ADDENDUM NO. 1

DATE: February 24, 2025

PROJECT: Magnolia Drive Baseball Field Phase I
Baker, Louisiana

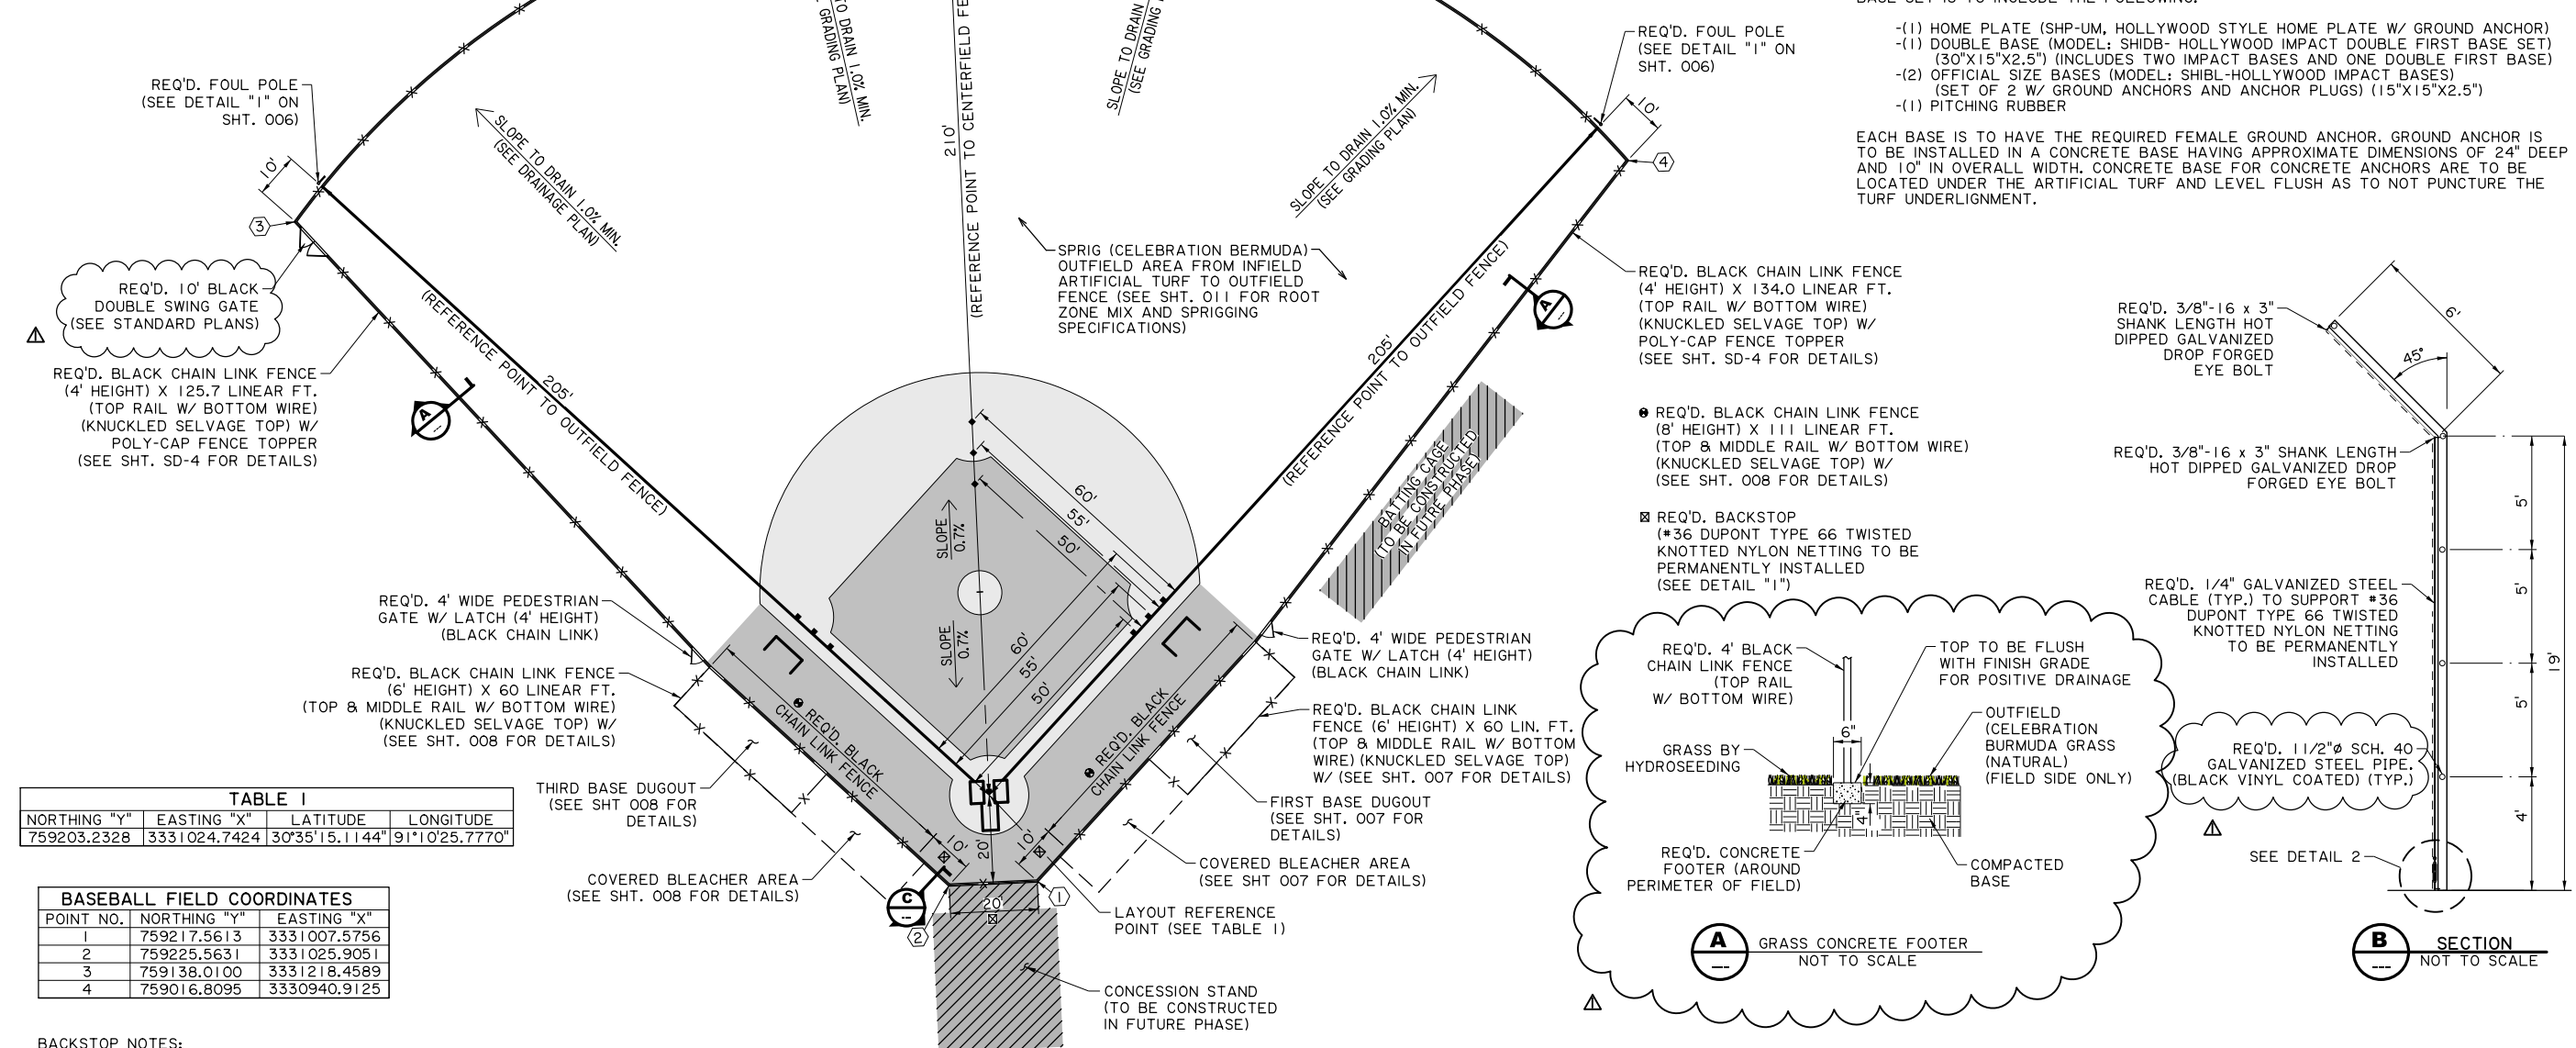
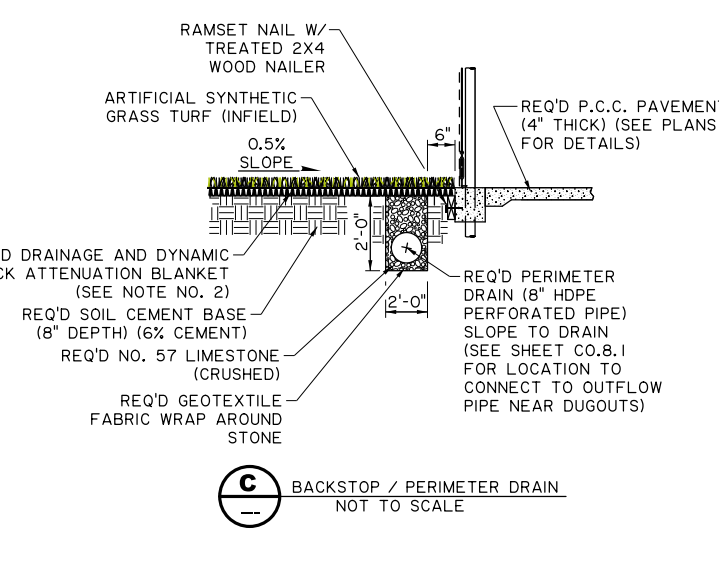
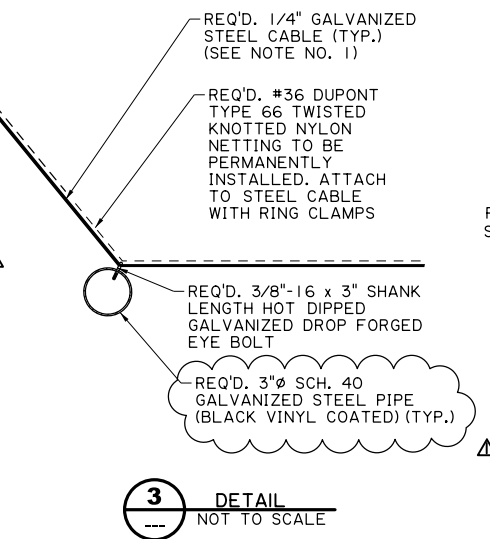
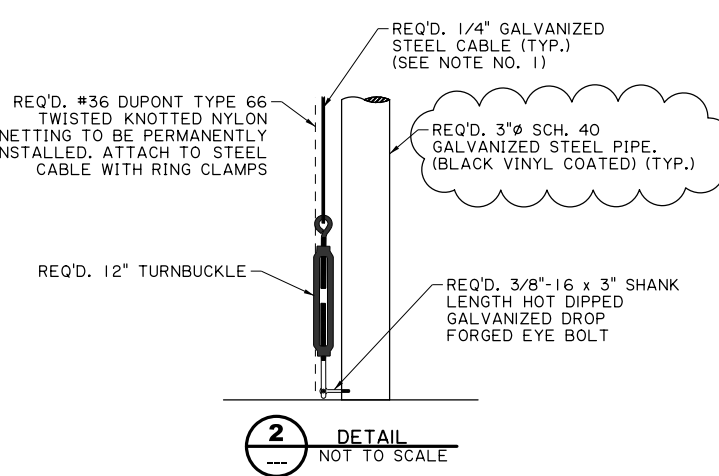
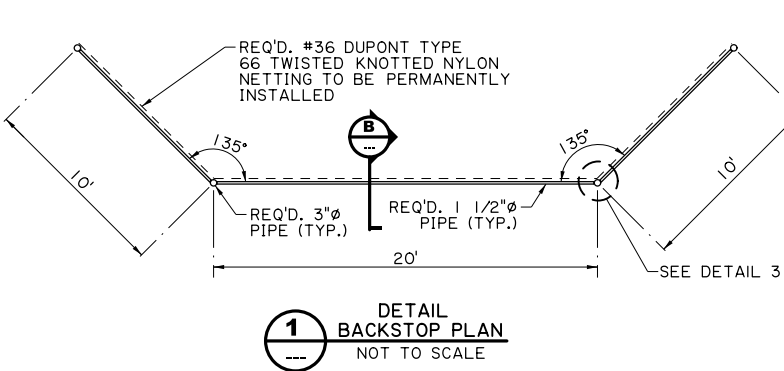
- 11) There are 2 references for the netting #18 & #36. 1 is golf netting and the other is for baseball. Please clarify.
 - a. #36 shall be used throughout backstop netting as detailed on Sheet 004 of the construction plans.

- 12) Drawing shows horizontal and vertical cables with eye bolts. Will there be a concrete footing for the eye bolts to be installed?
 - a. Reference Sheet 004, detail 2 of the construction plans for desired post connection.

- 14) Using galvanized posts for back stop and dugouts and painting black. We have seen numerous problems with this in the past of the paint flaking and peeling.

- a. Construction plan sheets 003 and 004 have been revised to call out a 10' wide double gate.
- 16) Will the City desire to reclaim anything from electrical removal (i.e. poles, wires, etc.)?

- a. All back stop posts to be black vinyl coated to match the fence posts. See revised Sheet 004 for required post coating.
- 15) 8' wide double gate to access the field. We typically install at least a 12'-16' wide double gate for emergency or maintenance vehicles to get on the field if needed.

TURF ESTABLISHMENT PLAN

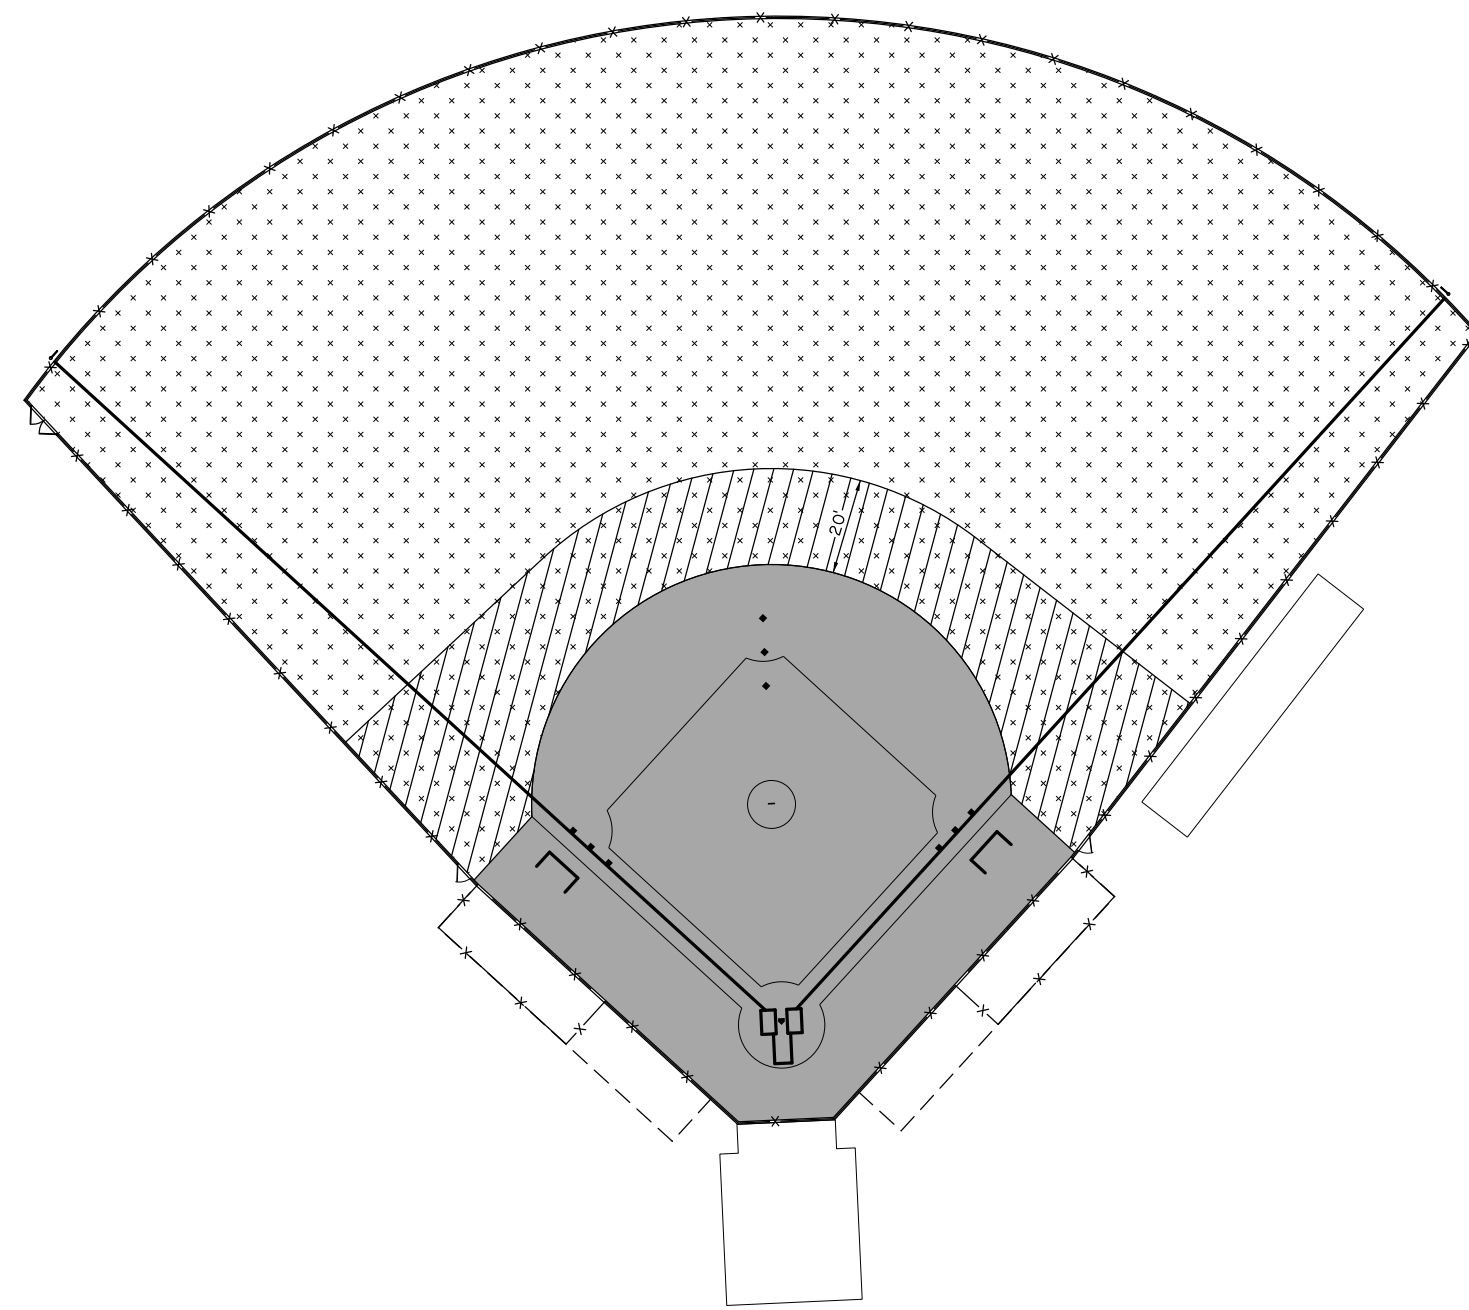
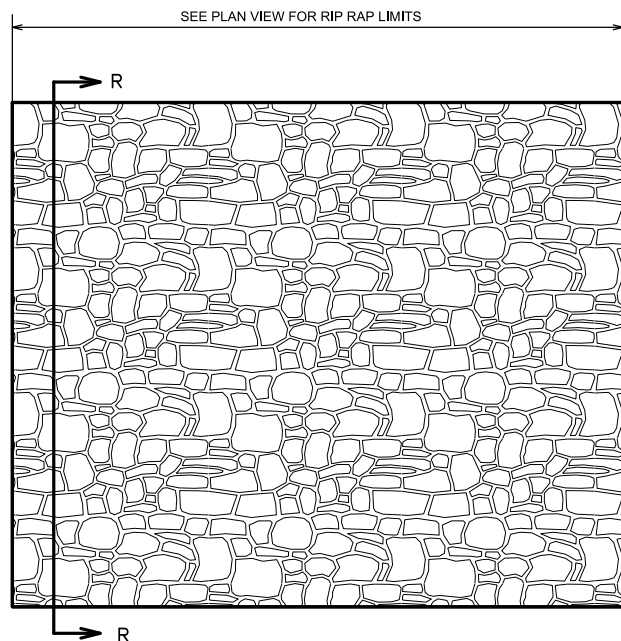
- 1) Synthetic turf infield shall be the responsibility of the contractor. Sheet 011 of the plans was revised to clarify this requirement.
- 2) Contractor shall remove the existing concrete slab located behind home plate (in future concession stand location). Removal was added to Sheet 002 and Sheet 003.

LIMITS OF RIPRAP PLACEMENT
FRONT VIEW
NO SCALE

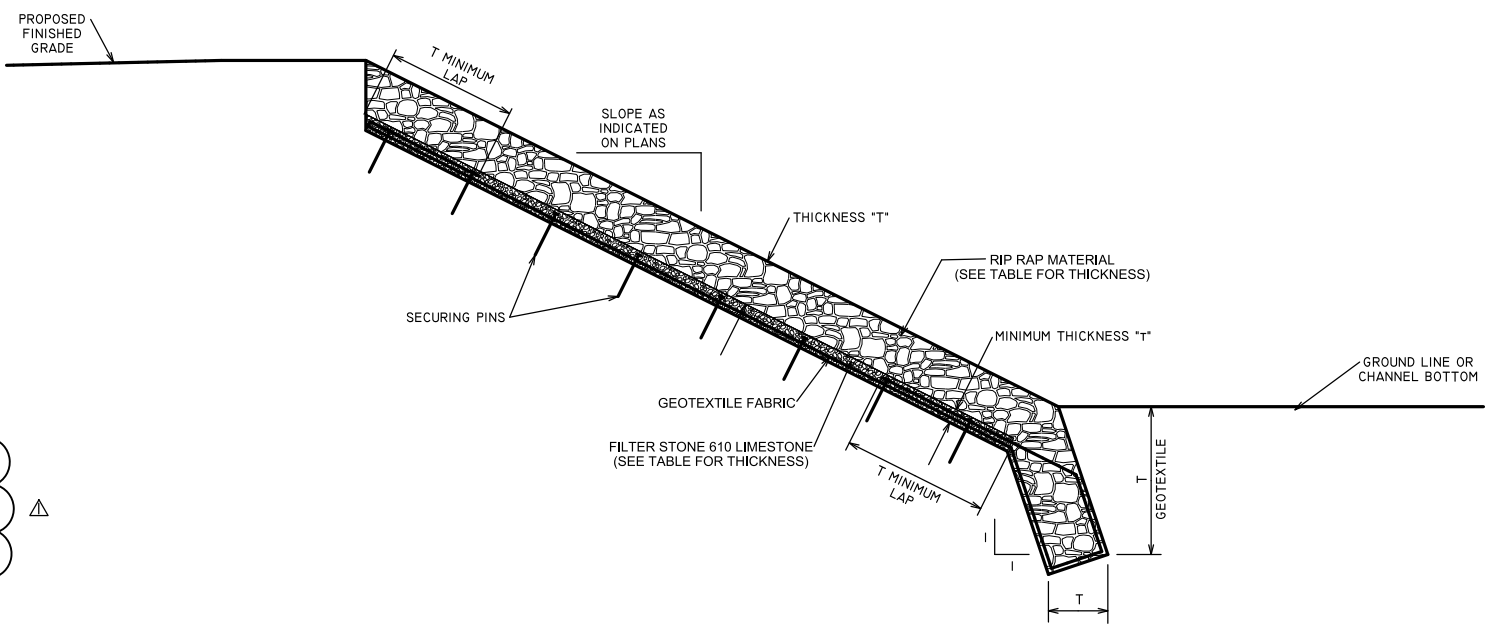
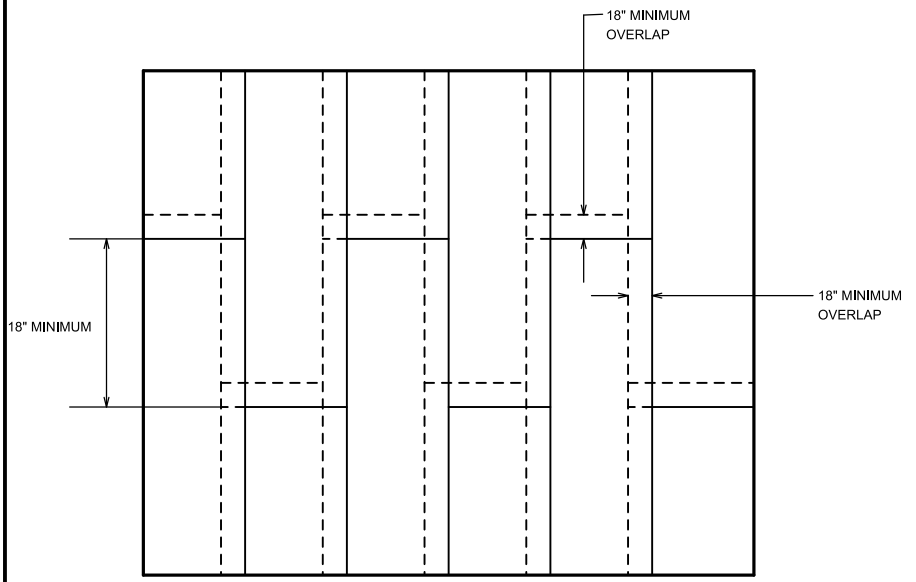
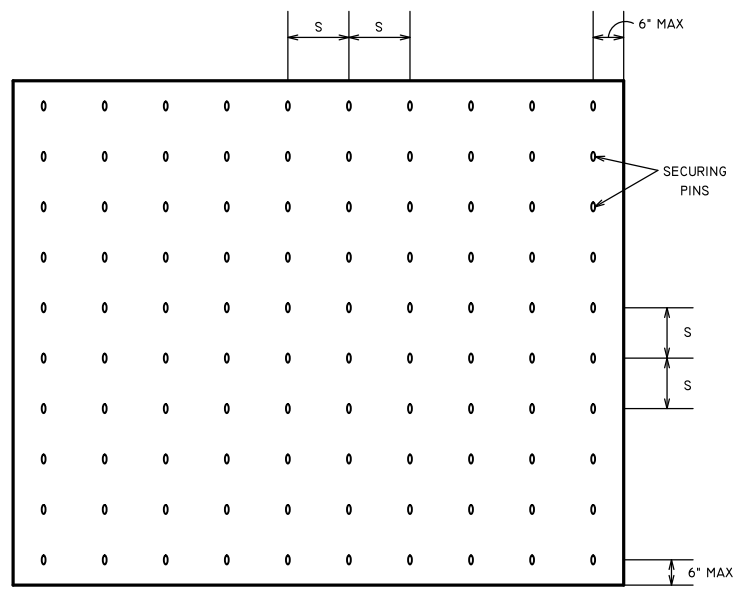
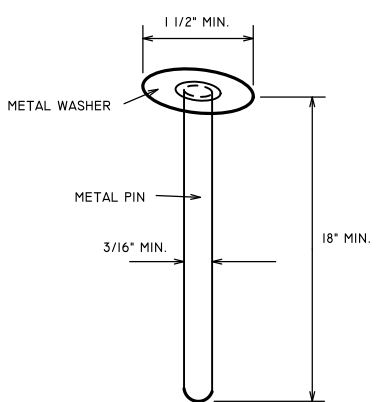
- 9) May I get some clarification on your limestone quantity of 81 tons? What other areas need limestone besides the drainage underneath the turf?
 - a. The limestone quantity was intended to be for the 3rd base line drainage outfall. The intent is to have limestone between the geotextile fabric and the rip rap material, as shown in the standard detail on sheet SD-3, The quantity should be 10 tons of limestone, and the standard detail has been revised to include 10 lb class rip rap, with a minimum thickness of 4" for the stone.
